WATERFRONT STATION

SECOND STAGE PUD APPLICATION

REVISIONS PACKAGE

MAY 13, 2014

REVISED
WEST (MAKEMIE PLACE) ELEVATION
WATERFRONT 1001 4TH STREET, LLC

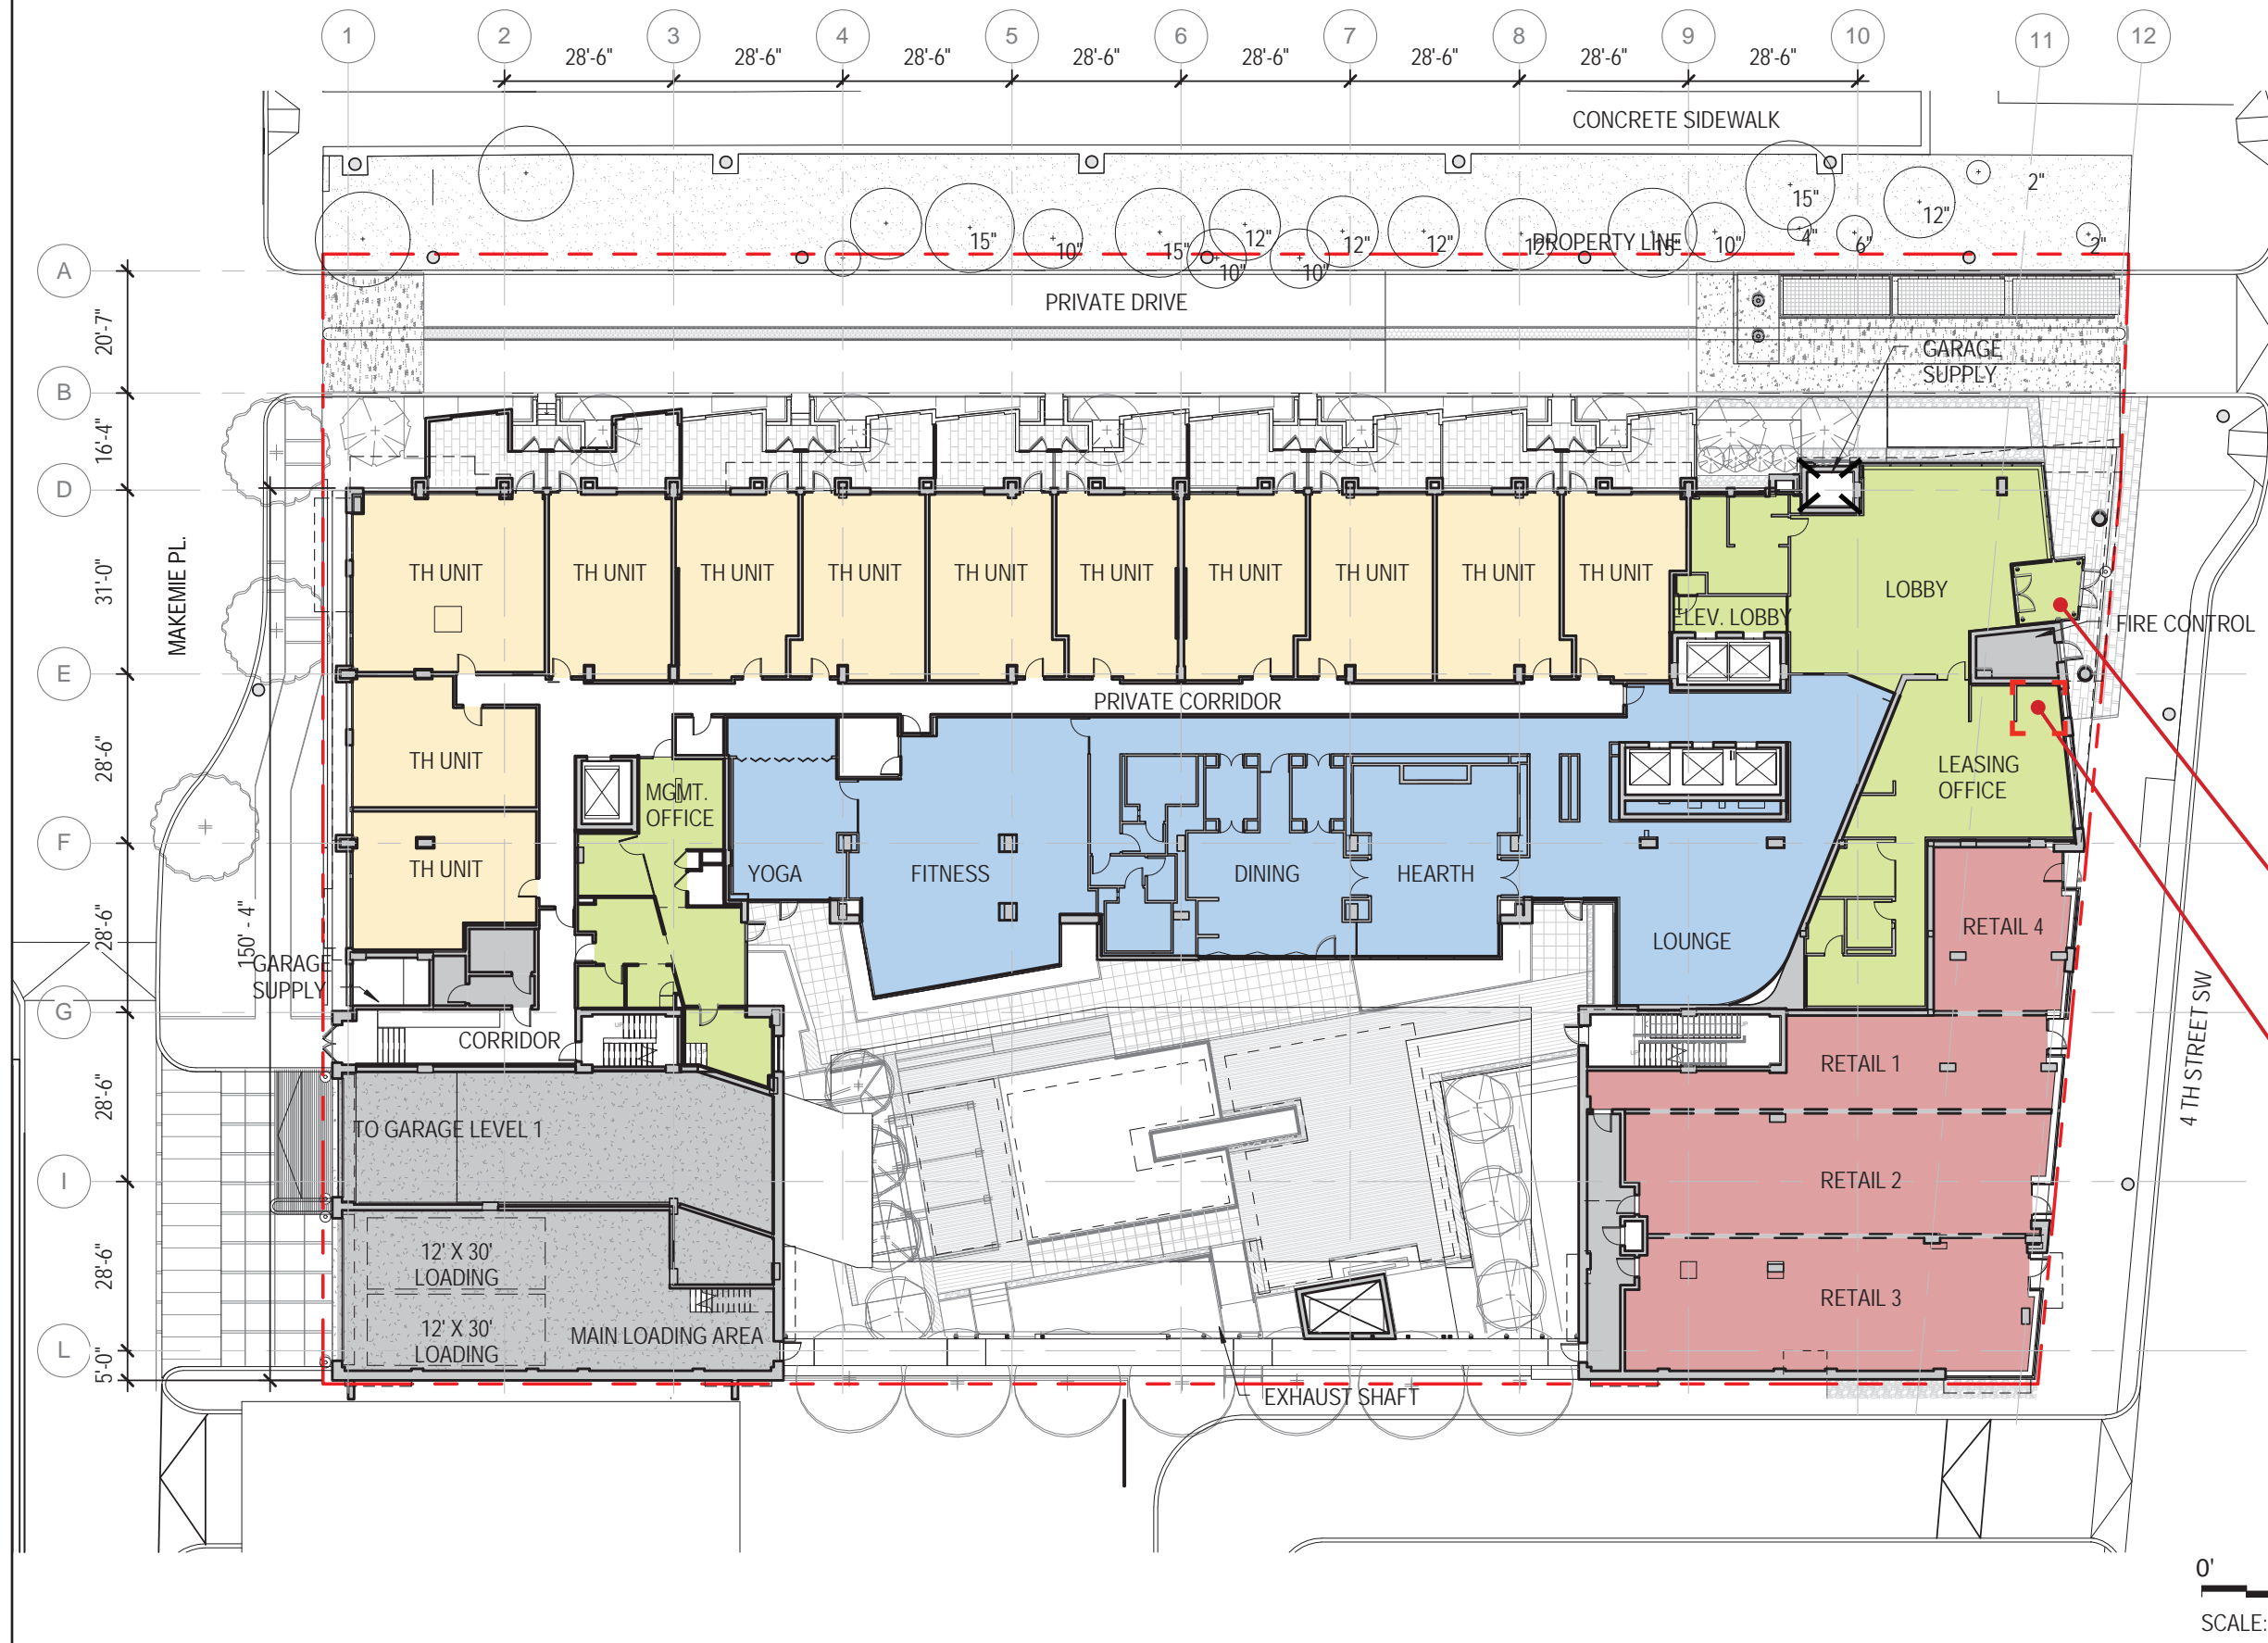
notch in building moved
north 8'-2" to coordinate with
interior unit redesign

additional 4'-0" height
required for overrun of
previously indicated elevator.
Top of elevator at 149.88'
(16'-0" above roof)

balcony stack moved north
23'-6" to coordinate with
interior unit redesign

balcony stack moved south
4'-0" to coordinate with
interior unit redesign

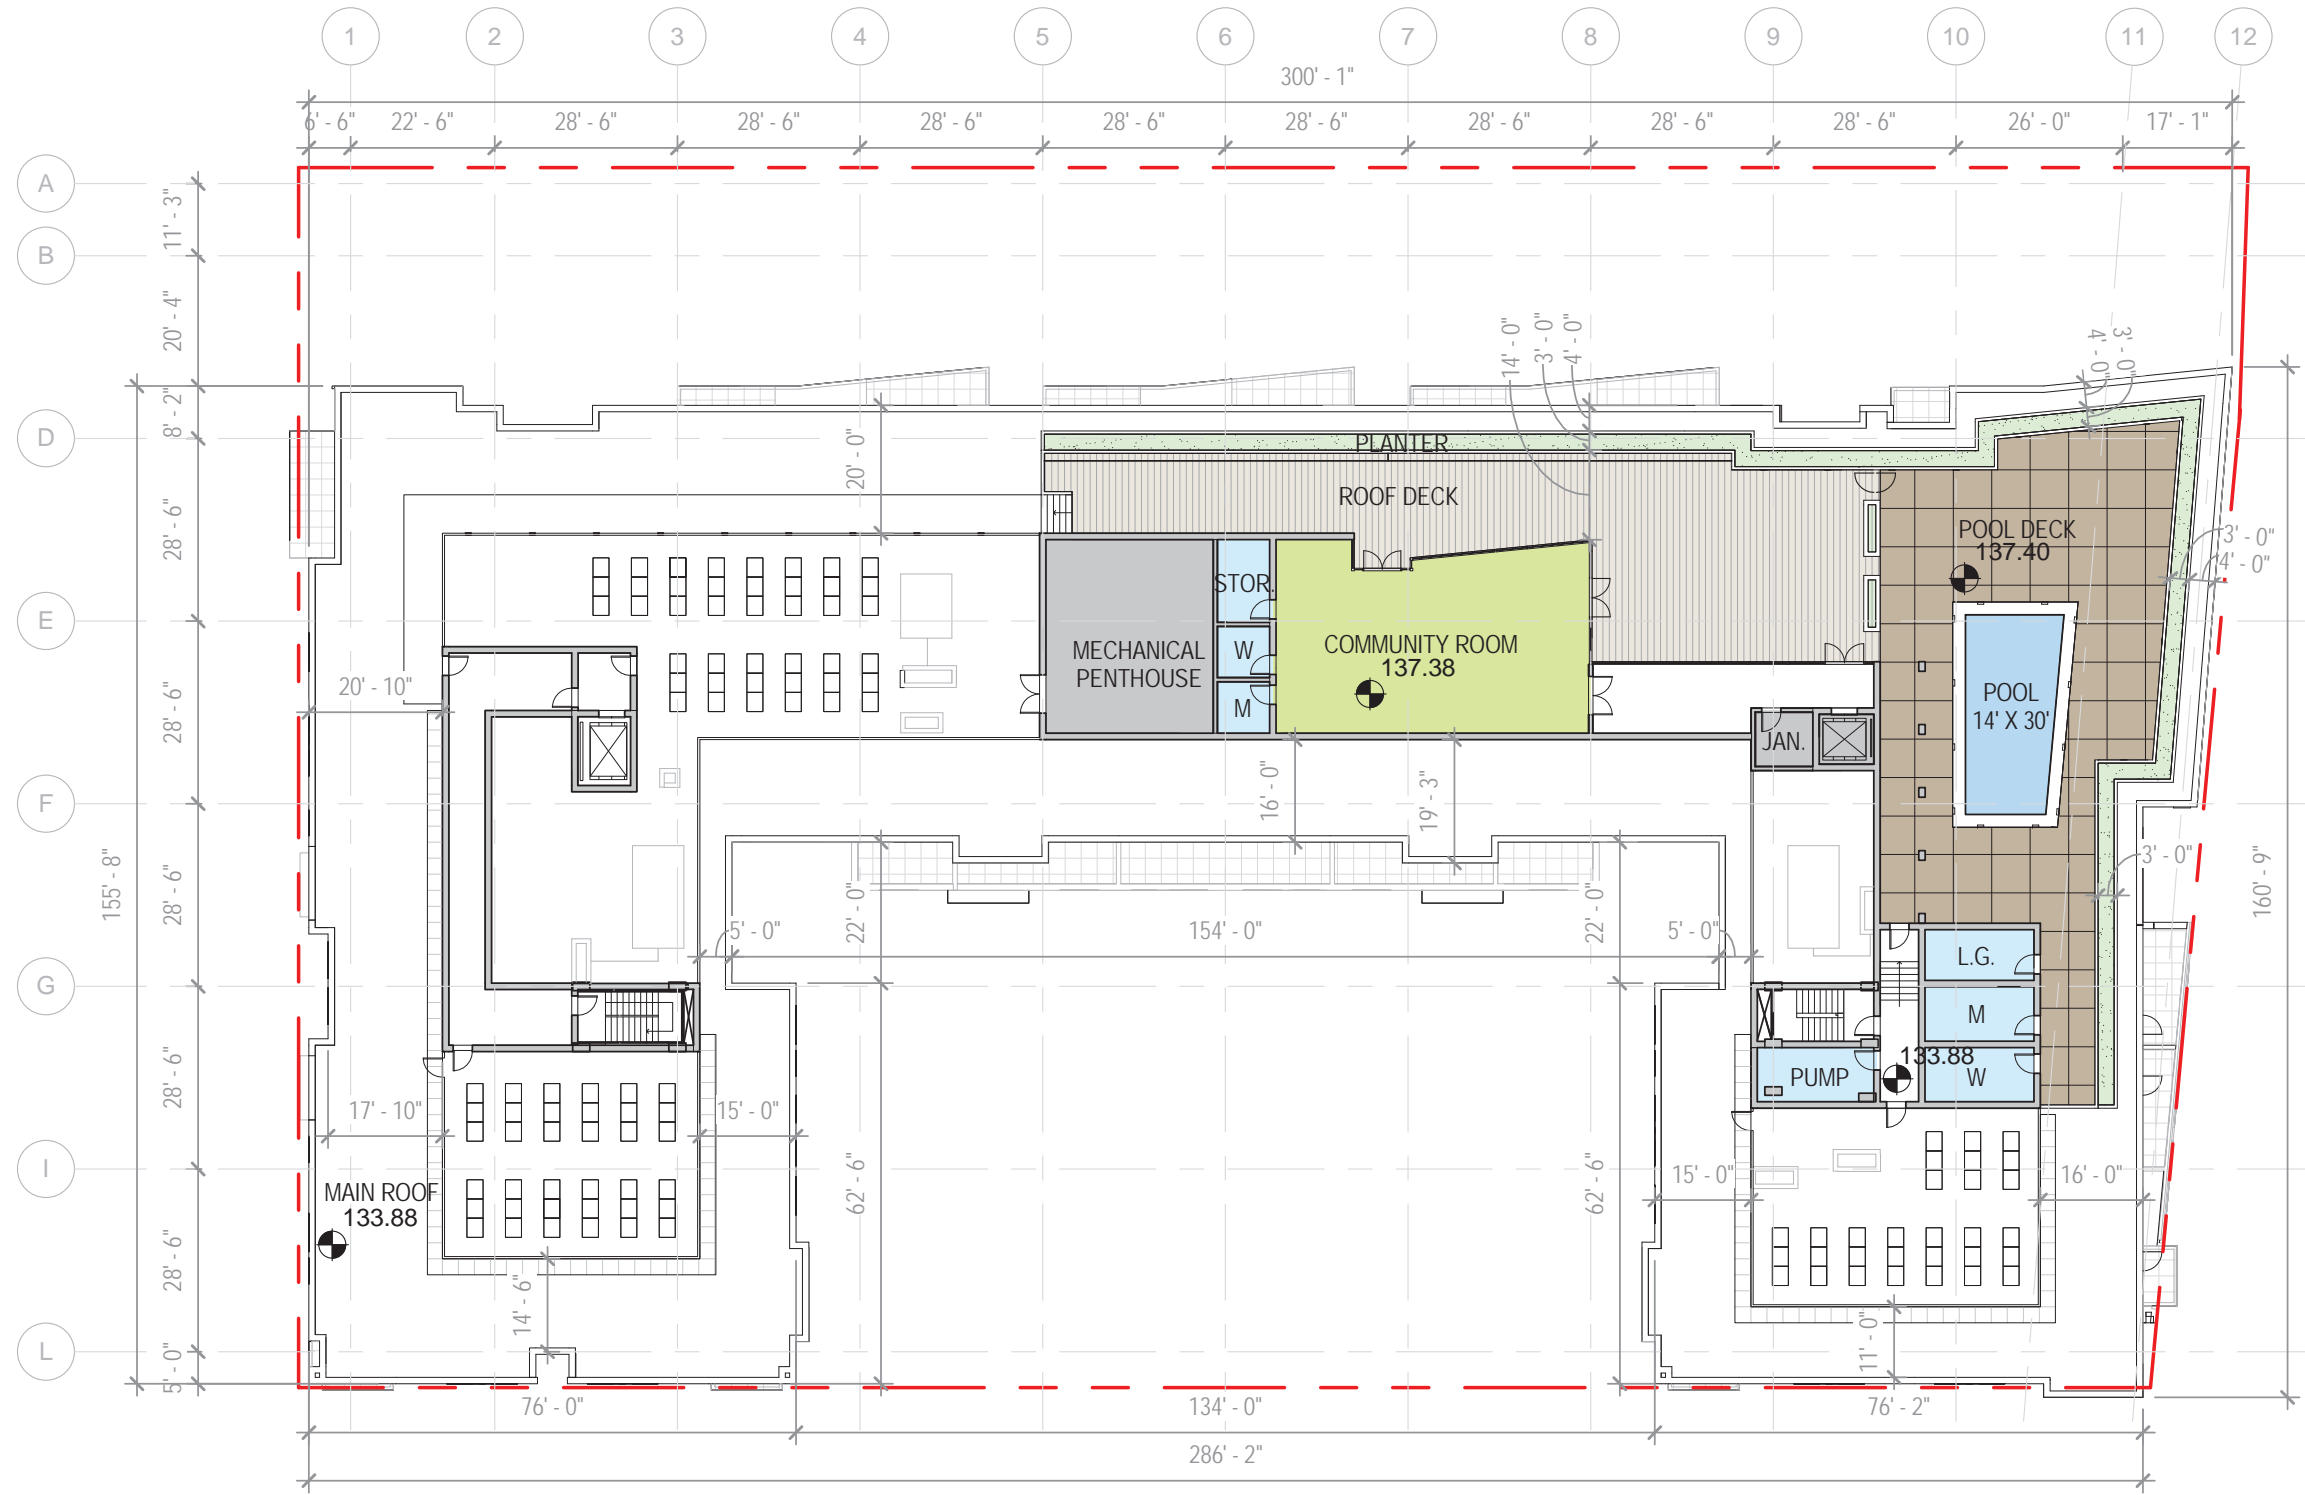
residential entrance vestibule moved north approximately 4'-8" to coordinate with interiors redesign

garage intake louver relocated to North (Private Alley) elevation and replaced with storefront and brick.
